Project Name: 2022 CDBG Grant WWTP Improvements

Addendum No.: 1

Date of Addendum: July 27, 2022

CAT CREEK LIFT STATION
SECTIONS AND DETAILS

DIMENSIONS AND WEIGHTS (CONT.)

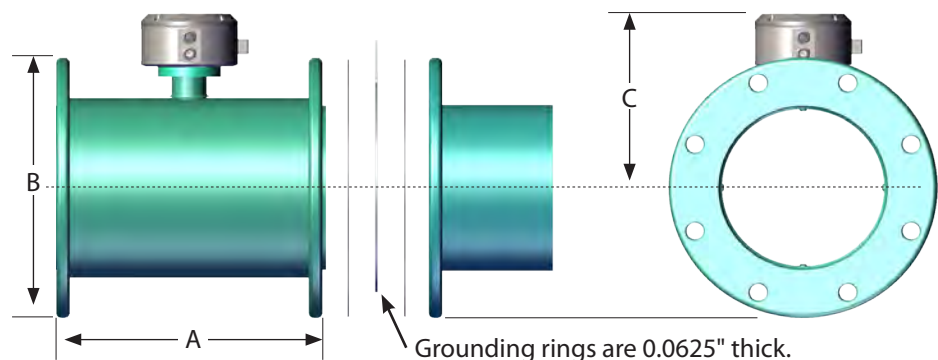
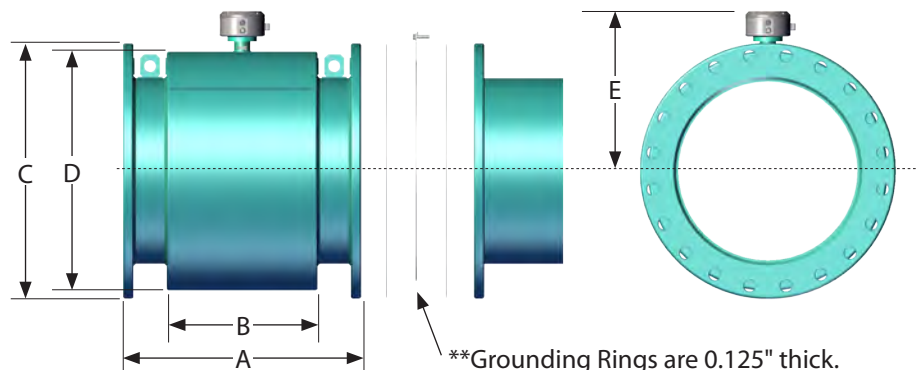
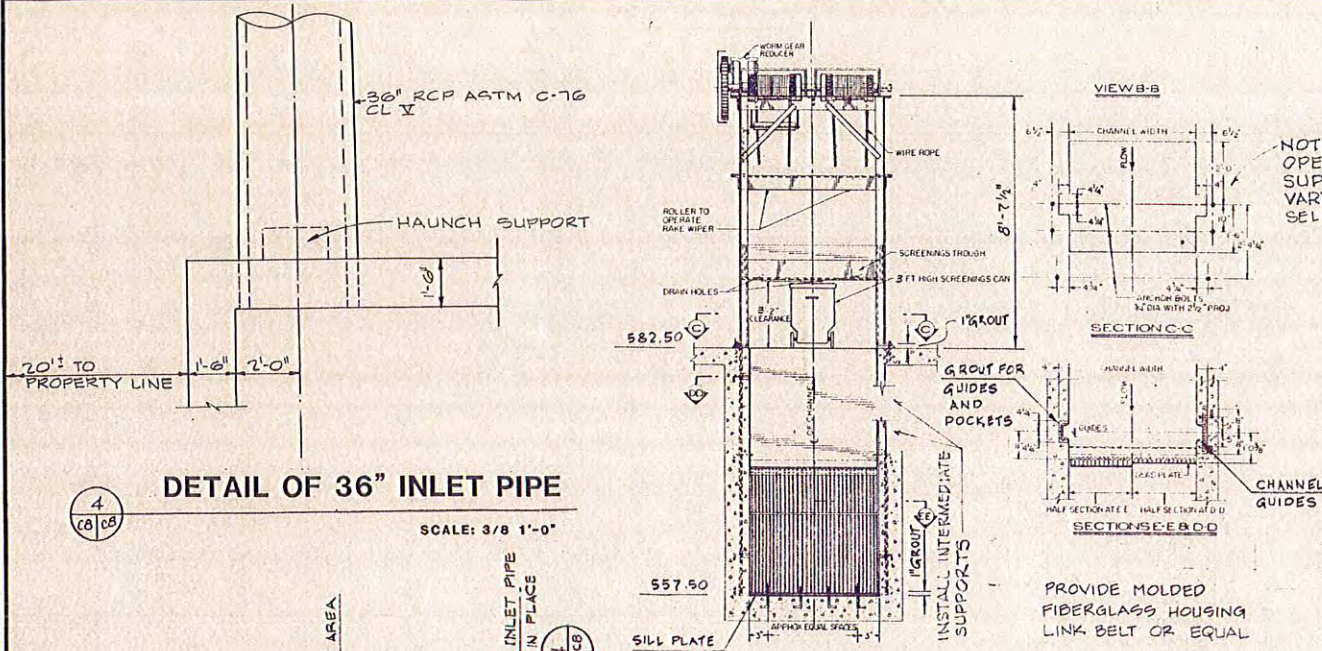
- d. The chlorine contact basin is approximately 10 feet deep. We do not have an issue exposing the sidewall of this structure. However, no undercut of the foundation will be allowed.
- e. A specification sheet for the meter is attached to this addendum.
- f. The flow meter shall be provided by the OWNER. All other items shall be supplied by the contractor.
- g. All electrical supplies shall be provided by the contractor. All SCADA connections shall be completed by contractor's electrician and coordinated with the owner and owner's SCADA technician.

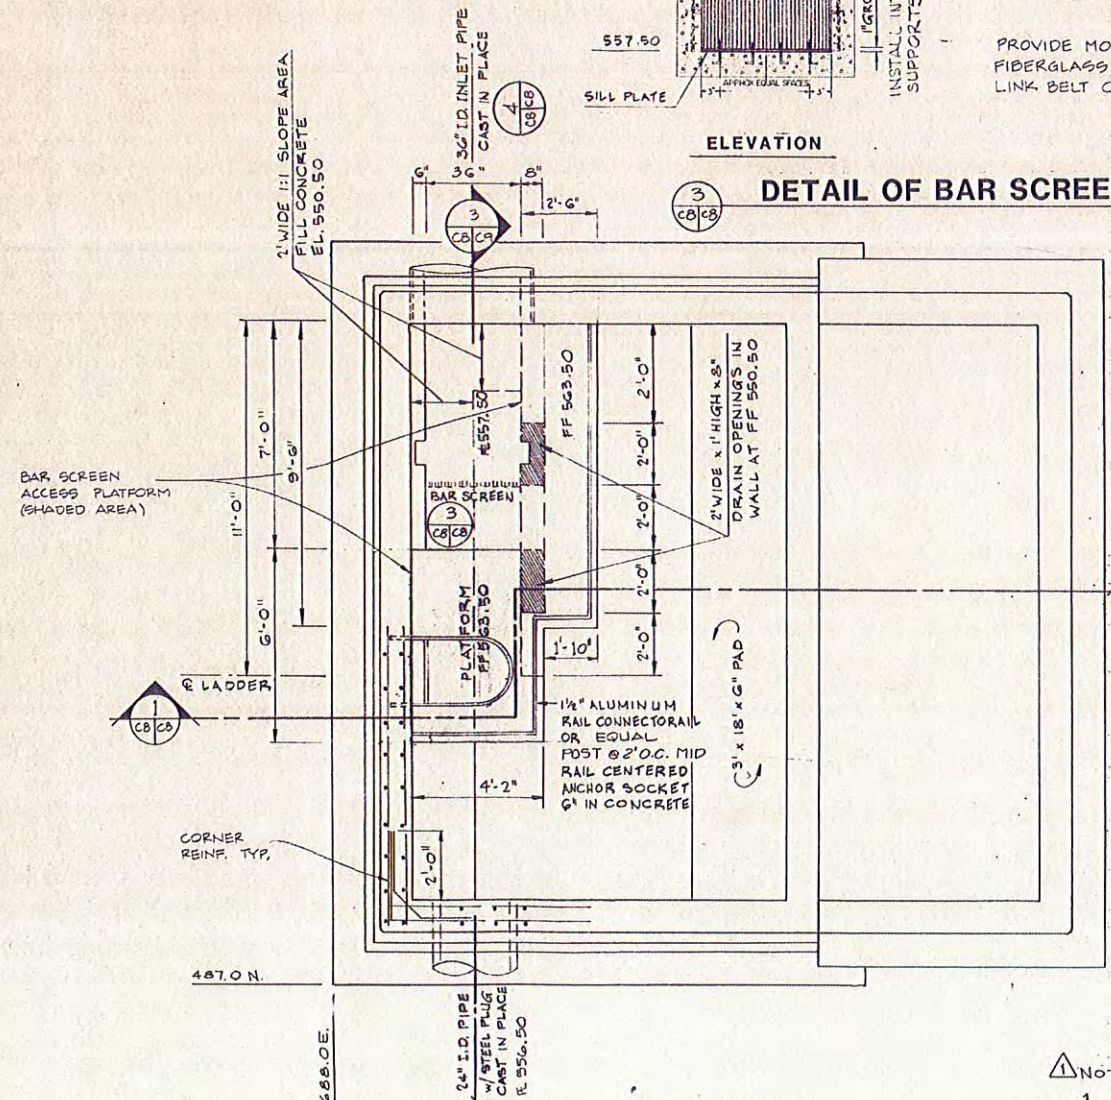
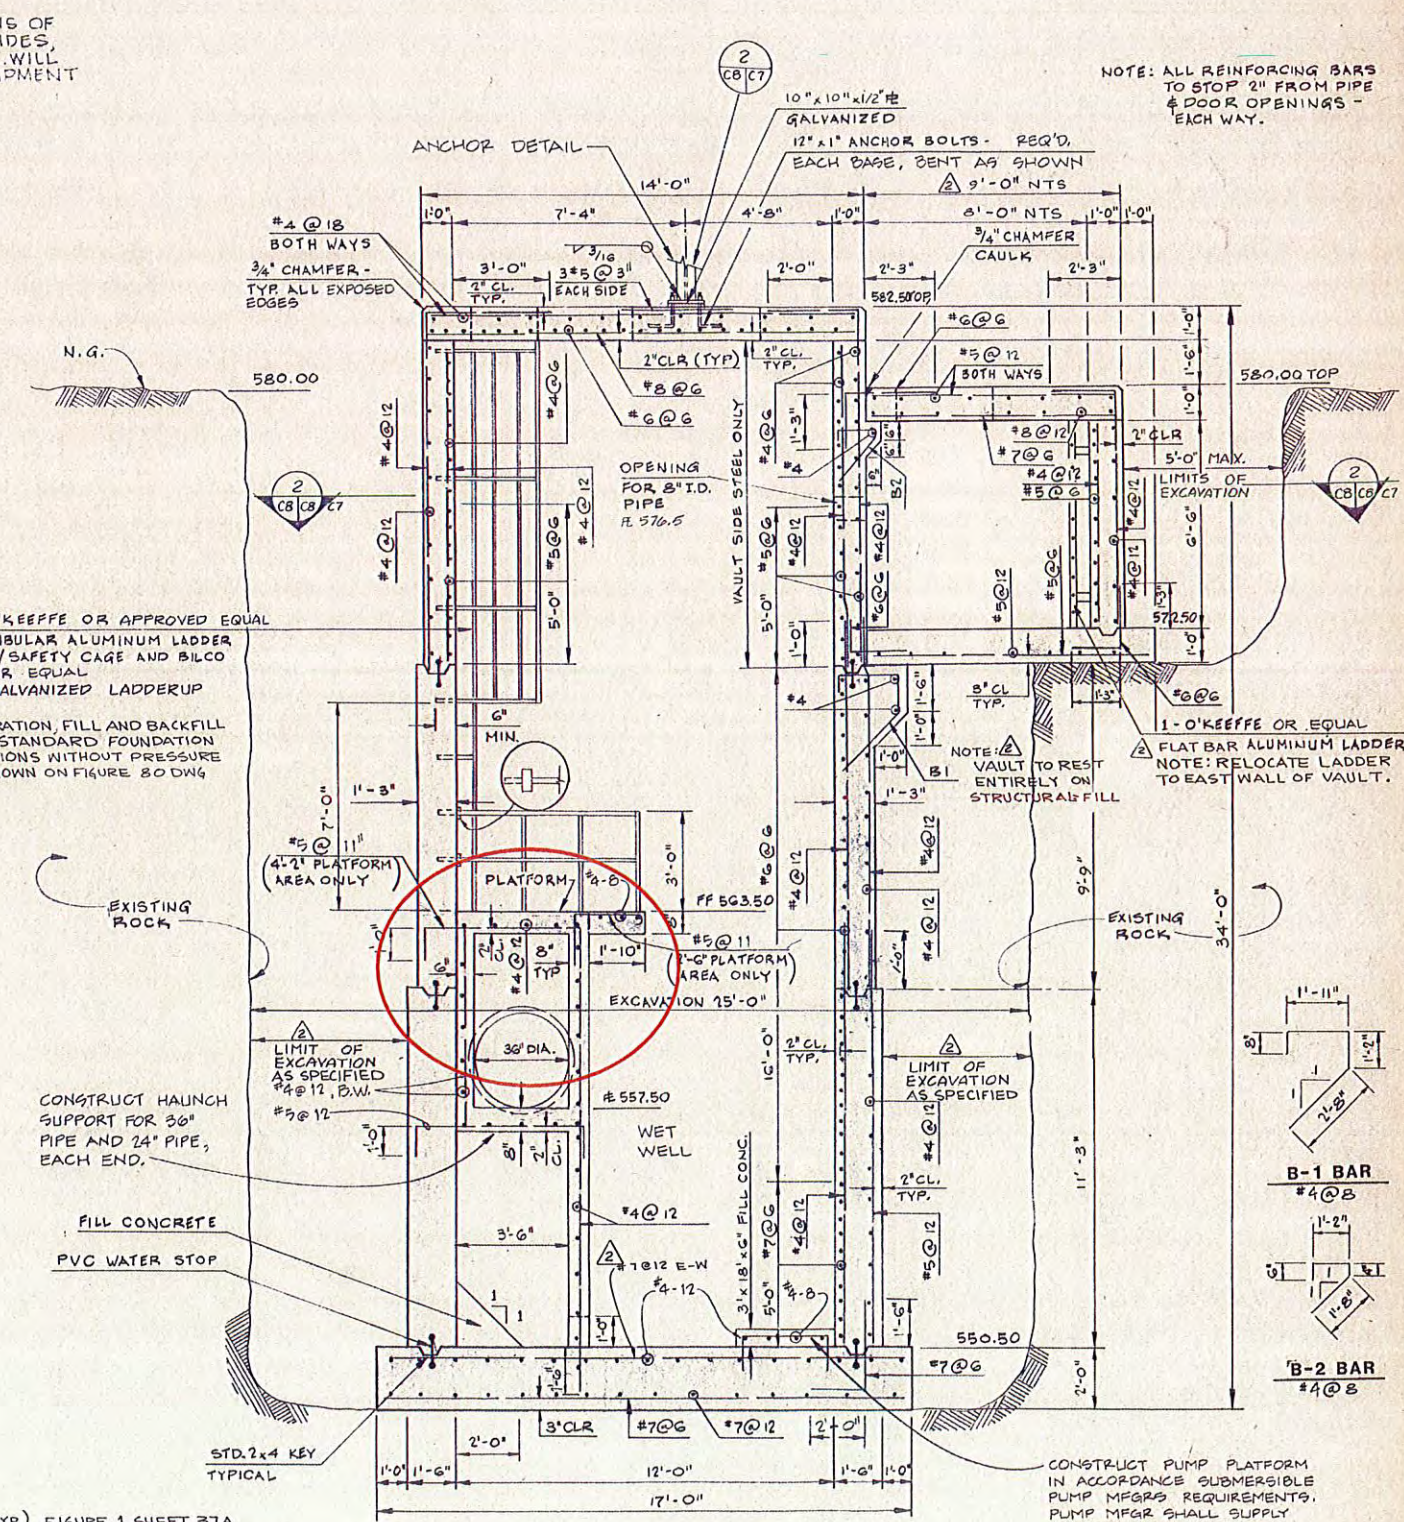
1. CAT CREEK SITE:
 - a. General Clarifications:
 - i. All concrete used to patch holes/openings shall be fiber reinforced. Epoxy coated rebar shall be used and placed on 8" centers, each way.
 - ii. The concrete lid/deck on the lift station is 12" thick. A plan sheet from the original lift station is attached to better illustrate the wetwell dimensions. All other items and equipment shown shall be ignored as many of these items no longer exist.
